Subject: 10CFR21 Reporting of Defects and Non-Compliance -  
Engine Systems, Inc. Report No. 10CFR21-0134, Rev. 0

EMD Cylinder Head with Fireface Thickness Below Specification  
Cylinder Head P/N 40121485

**Report No. 10CFR21-0134**

Fireface → **Figure 1: Cylinder Head (side view)**

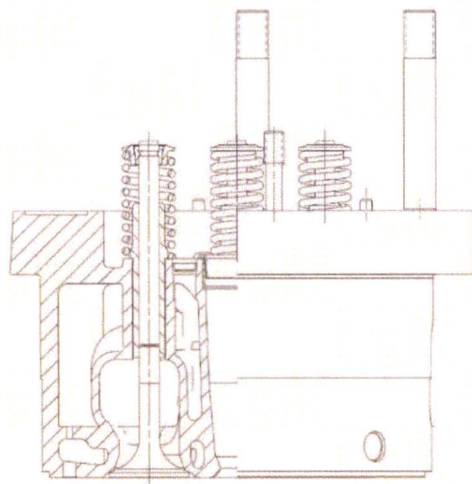
*A fatigue crack was discovered in the fireface of an EMD cylinder head installed on an emergency diesel generator set. The crack initiated on the coolant side and propagated through the fireface wall to the combustion side resulting in a water leak. Fatigue failure was likely caused by a reduced fireface thickness which reduced overall rigidity of the fireface, allowing increased deformation and ultimately failure due to high tensile stress at the blend between the fireface and valve seat.*

**Photo 1: Location of Serial Number Identification  
(ex. S/N 20L0707)**

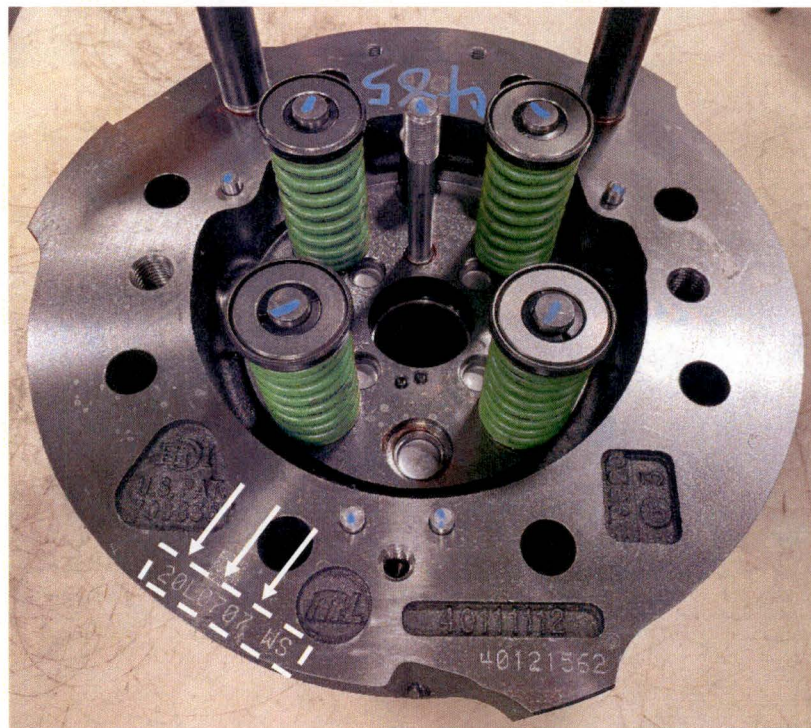
*To ease identification of affected cylinder heads, Photo 1 below shows location of serial number stamping on the head.*

**Figure 3**  
**Sonic Thickness**  
**Measurement Locations**

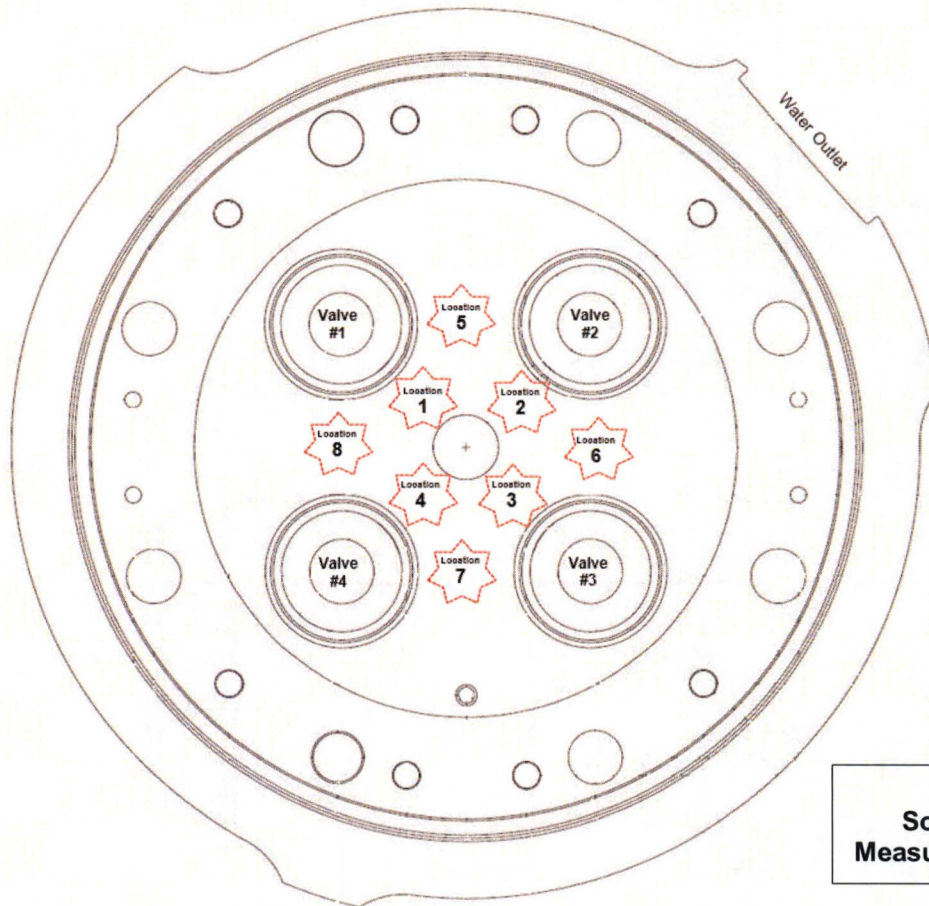
To perform an ultrasonic inspection of the cylinder head fireface, the map below shows locations of interest. For best results, a 2.5 Mhz probe should be used with the ultrasonic thickness gauge. Fireface thickness at these eight (8) locations should be no less than 0.230".

*To prevent reoccurrence, ESI has revised the dedication package to increase the number of ultrasonic thickness inspection points. An additional enhancement is the inclusion of an inspection map for guidance and clarity of the locations to be measured. The revision was implemented on March 15, 2022.*
